Minutes – Executive Policy Committee – December 5, 2018

Item No. 6 Subdivision and Rezoning – 1493 Magnus Avenue (Point Douglas Ward) File DASZ 9/2018 [c/r DAV 125313/2018D]

Title: DASZ 9/2018 – 1493 Magnus Ave

SUBJECT: To rezone the subject property to an "RMF-S" Residential Multi-Family (Small) zoning district for the purposes of constructing a townhouse development

Figure 1: Aerial Photo of Subject Site and Surrounding Uses *(flown 2016)*

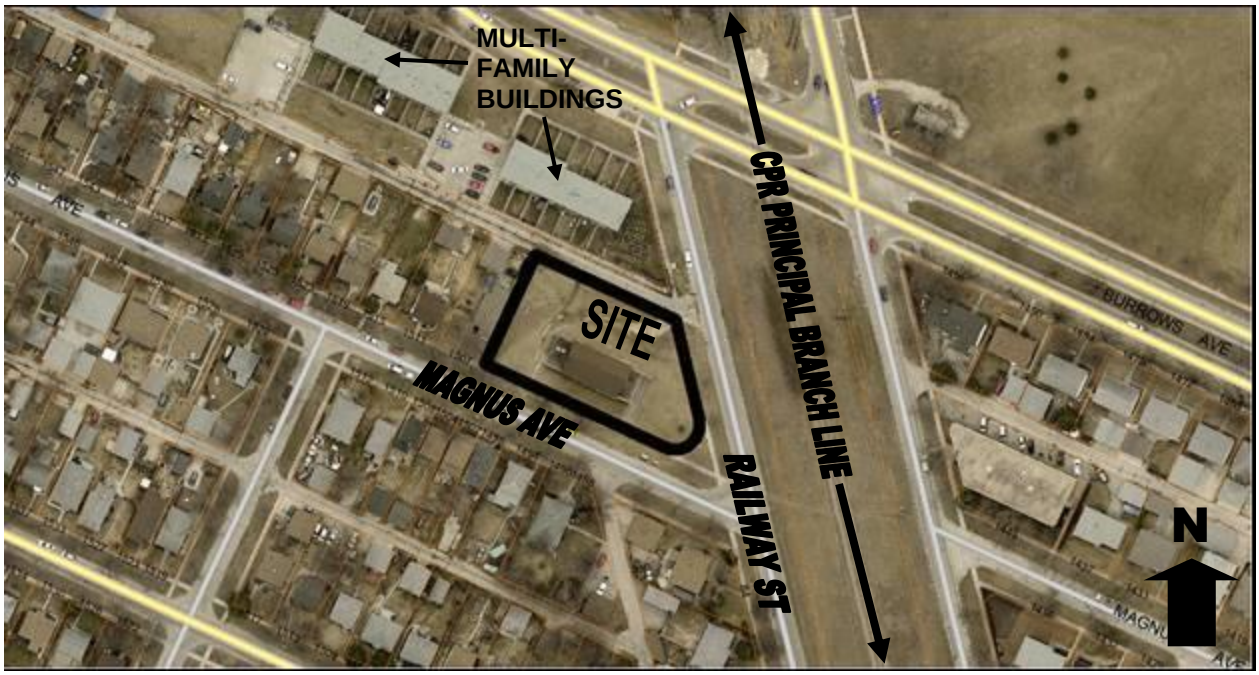
- The subject property is located on the north east corner of Magnus Avenue and Railway Street, in the Burrows - Keewatin neighbourhood of the Point Douglas ward.
- Currently on the property is a place of worship, which is proposed to be demolished to make way for the proposed multi-family (townhouse) development.
- The site is in the "Areas of Stability – Mature Communities" policy area under the Complete Communities Direction Strategy (By-law 68/2010).
- The site is zoned "R1-M" Residential Single-Family (Medium) district under Winnipeg Zoning By-law 200/2006.

Schedule "A" for File No. DASZ 9/2018, Lord Selkirk – West KIldonan Community Committee, dated May 8, 2018

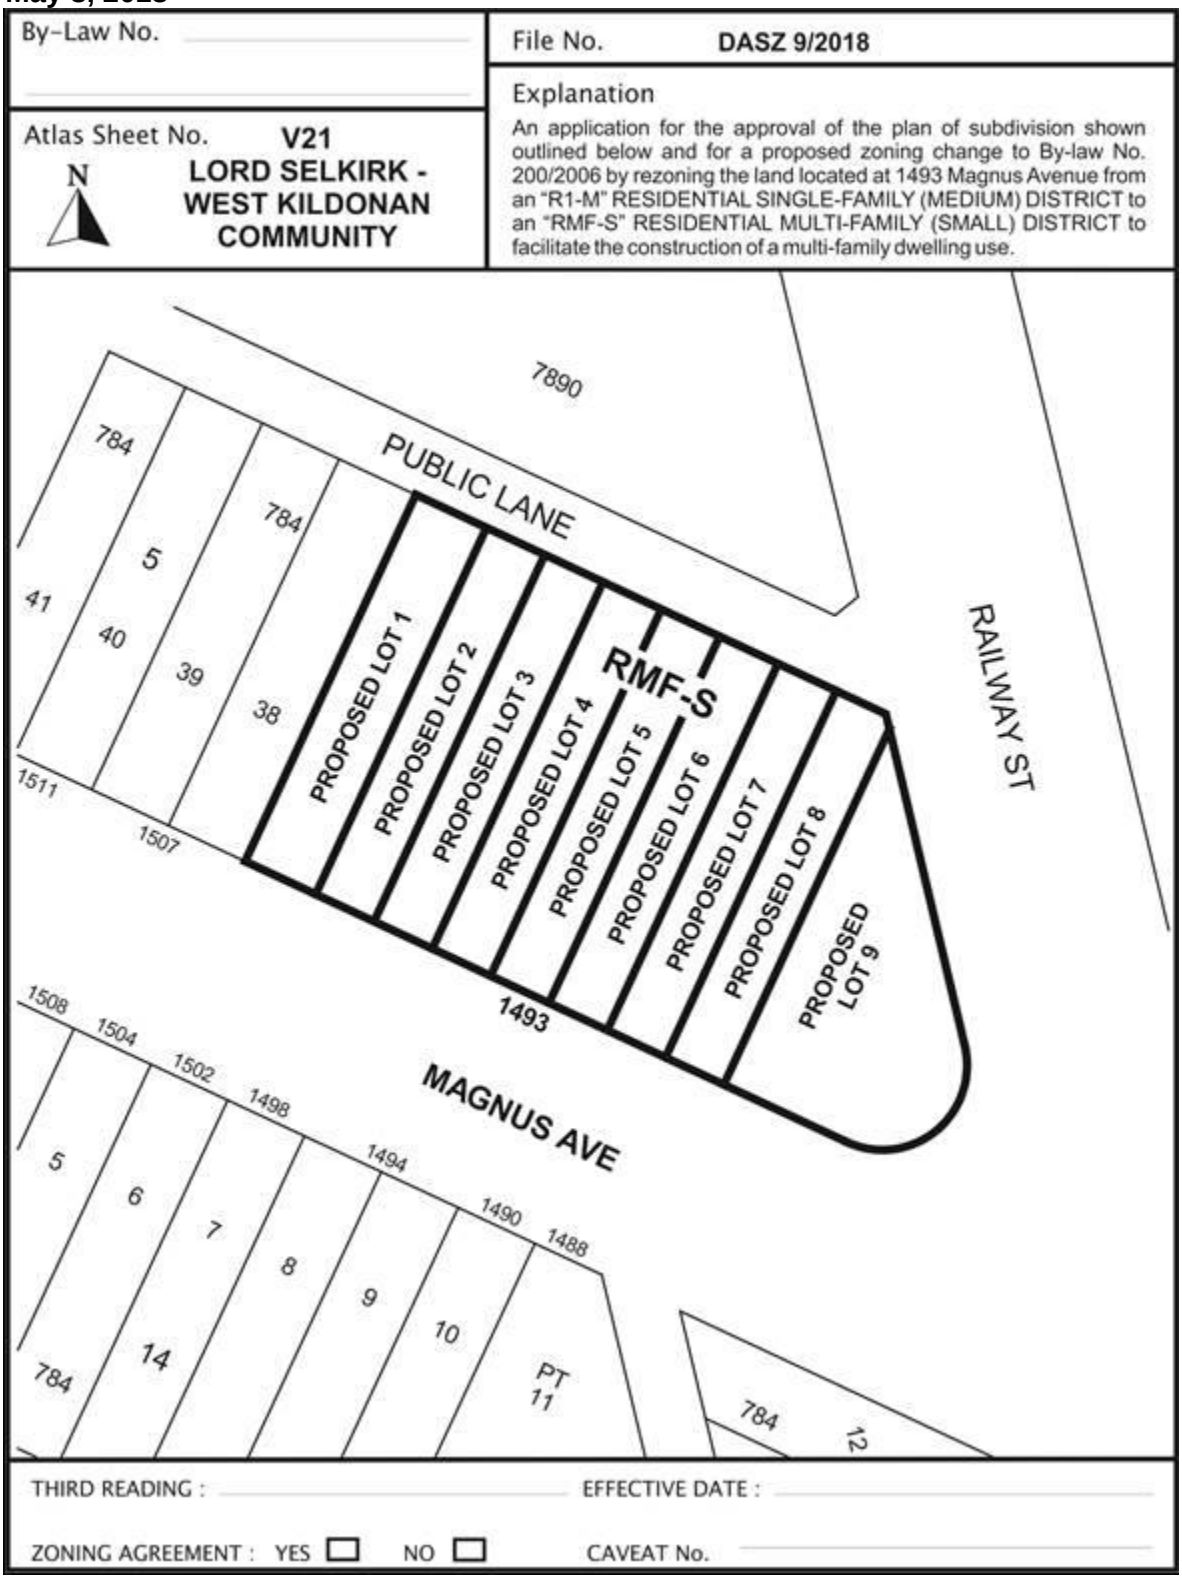
- However, there are aspects of the design of the proposed use that are inconsistent and incompatible with the existing character of the neighbourhood. Specifically, the site plan illustrates a private approach gaining access to proposed unit #9 from Magnus Ave. Given that the property is served by a public lane, the expectation is that all vehicular access to the site must be from the public lane. The Public Service believes there are alternatives to the design of the site to avoid the need for any approaches onto existing streets abutting the site. The length of the lane providing direct access to the subject site is approximately 150 feet which provides ample opportunity for site access.

- Given this situation, the Public Service recommends that proposed Lot 9 be amalgamated with Proposed Lot 8 to alleviate site access issues. To this end, a new Schedule (Schedule “D”) has been created and appended to this report and it is recommended it replace Schedule “A, the subdivision plan submitted by the applicant.

- *Reduced berm heights are possible where larger setbacks are proposed.*
- It is noted that the proponent's site plan does not adhere to the above standards. The applicant is aware of the concerns of the Public Service and Council direction, but wishes not to construct the berm. Instead of rejecting the application altogether, the Urban Planning Division is recommending the above requirements be stated in recommended zoning agreement for this application.

- As noted previously in this report, the proposed private approach on Magnus Ave is not supported. Therefore, while the Public Service recommends approval of the zoning designation to allow multi-family development, the applicant will be expected to revise the site plan to remove the approach and take access from the existing public lane.

Schedule "B" for File No. DASZ 9/2018, Lord Selkirk – West Kildonan Community Committee, dated August 20, 2018

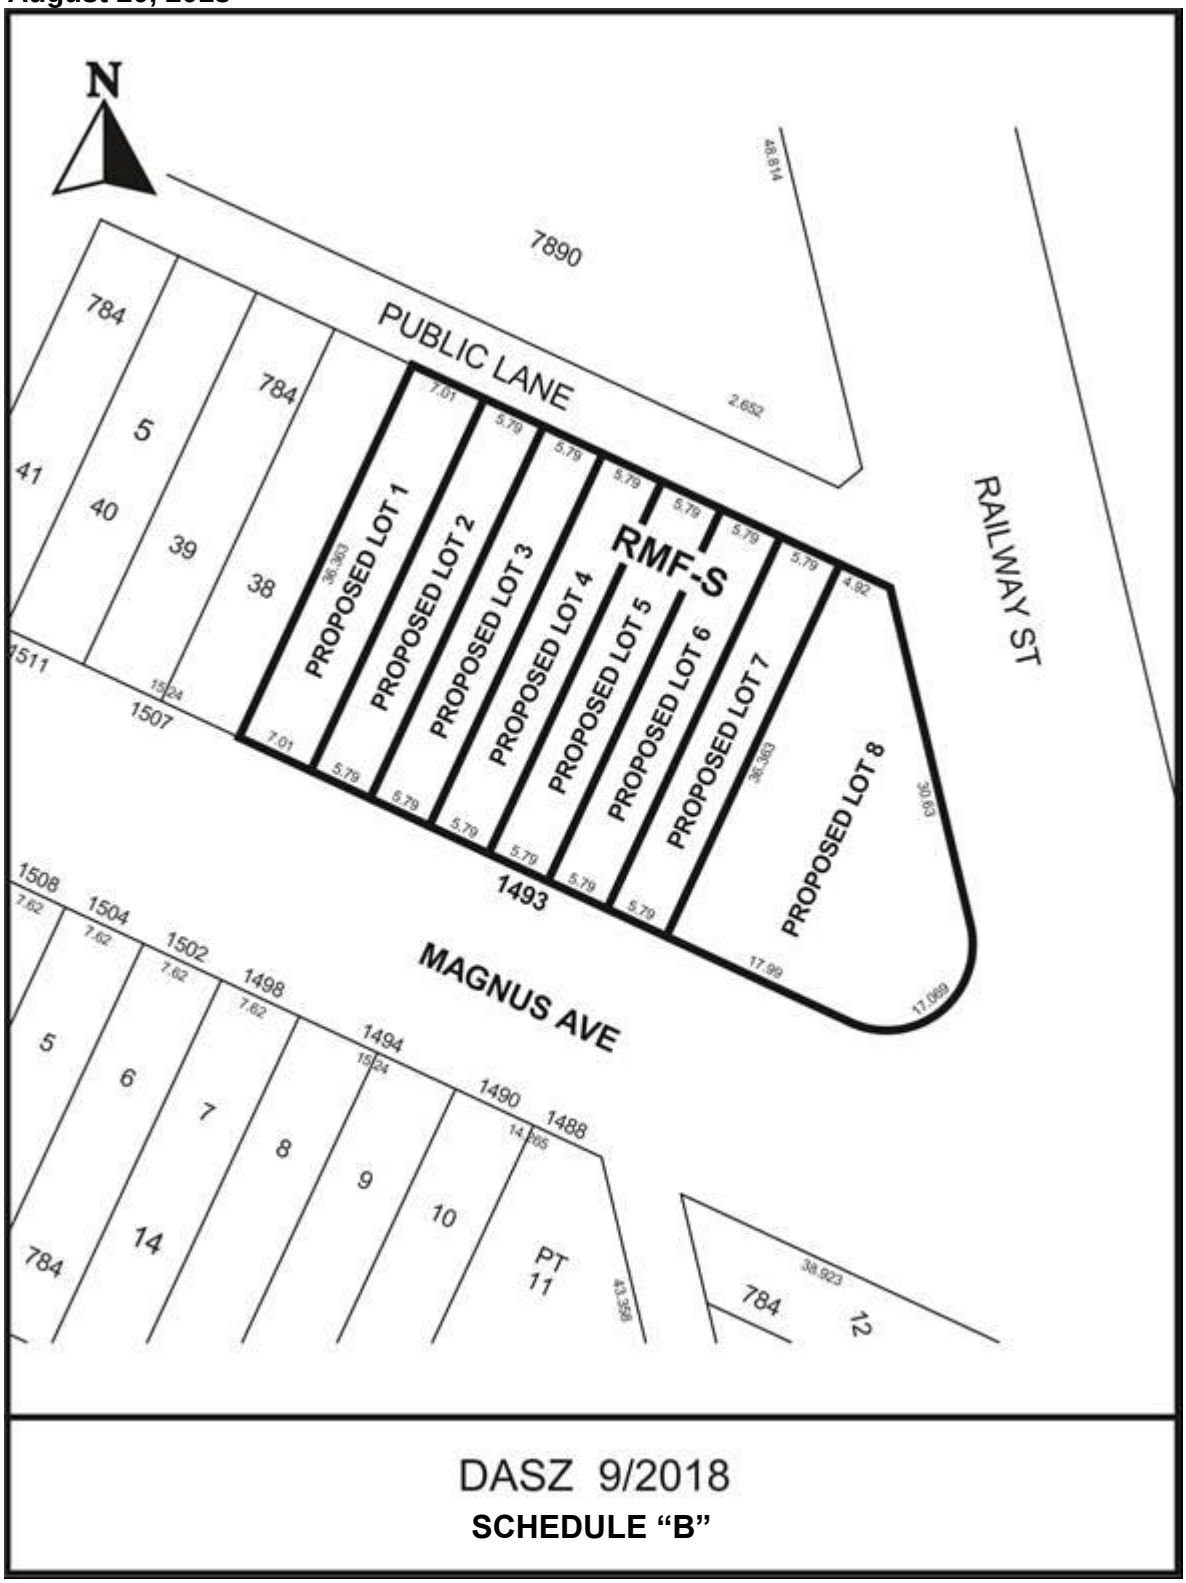
1. That the plan of subdivision proposed under File DASZ 9/2018 be approved for preparation as a plan of subdivision by a Manitoba Land Surveyor in accordance with Schedule "B" for File DASZ 9/2018 dated August 20, 2018 with such minor changes as may be required, and registration in the Winnipeg Land Titles Office subject to the following:

2. That The Winnipeg Zoning By-law No. 200/06 be amended by rezoning the subject land as shown on Schedule "B" for File DASZ 9/2018 dated August 20, 2018, to an "RMF-S" Residential Multi-Family (Small) District subject to the following conditions:
